[Docket No. 2003-NE-52-AD Amendment 39-13410; AD 2003-24-12R1]

Airworthiness Directives; Pratt & Whitney JT9D-3A, -7, -7A, -7F, -7H, -7AH, and -7J Turbofan Engines**AGENCY:** Federal Aviation Administration (FAA), DOT.**ACTION:** Final rule; request for comments.

2003-24-12R1 Pratt & Whitney:

Amendment 39-13410. Docket No. 2003-NE-52-AD. Revises AD 2003-24-12, Amendment 39-13381.

Figure 1

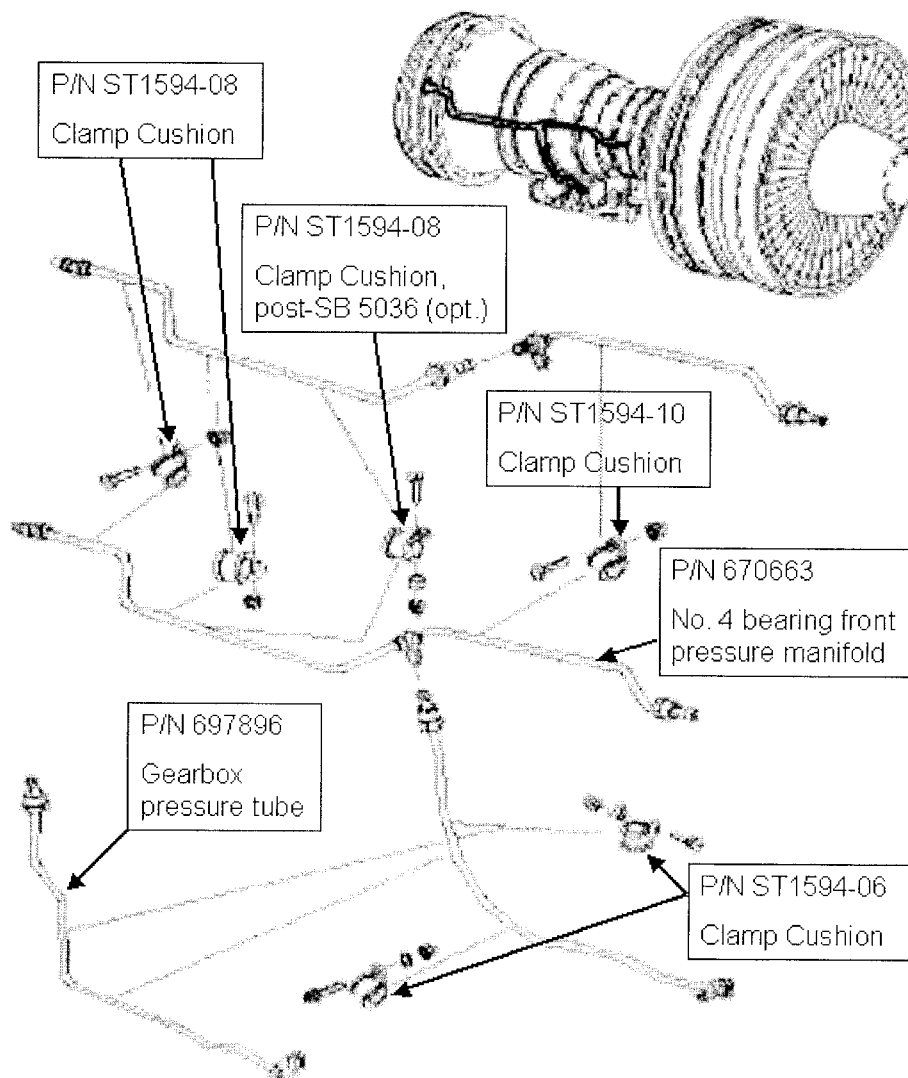
Since that AD was issued, errors in the depicted clamping configuration have been found. The clamping configuration must be correct to ensure that AD compliance can be achieved. Also, an operator has requested that as an option to inspecting dented tubing by passing a ball bearing through the tube, to add dent depth limit criteria for each specific part number tube. The manufacturer supports this optional method and we have added it to the AD. This method avoids having to disconnect the tube from the engine.

(d) This AD results from the need to correct errors in depicted clamping, to ensure that AD compliance can be achieved. The actions specified in this AD are intended to prevent engine fires caused by failed gearbox pressure tubes or failed No. 4 bearing front pressure manifolds.

(f) Visually inspect the clamp assemblies, P/Ns ST1594-06, ST1594-08, and ST1594-10, (see Figure 1 of this AD) that attach the gearbox pressure tube and the No. 4 bearing front pressure manifold to the engine. Replace clamp assemblies before further flight that are rejected by any of the following rejection criteria:

(g) If one or more clamp assemblies are rejected as described in paragraph (f) of this AD, or out of position or missing (see Figure 1 of this AD), clean any debris and oil from the outer surface of the gearbox pressure tube and No. 4 bearing front pressure manifold and visually inspect the tube and manifold. Repair or replace the affected tube or manifold before further flight if it is rejected by any of the following rejection criteria:

(h) Ensure that the gearbox pressure tube, No. 4 bearing front pressure manifold, and clamp assemblies are properly positioned, before further flight, as shown in Figure 1 of this AD.
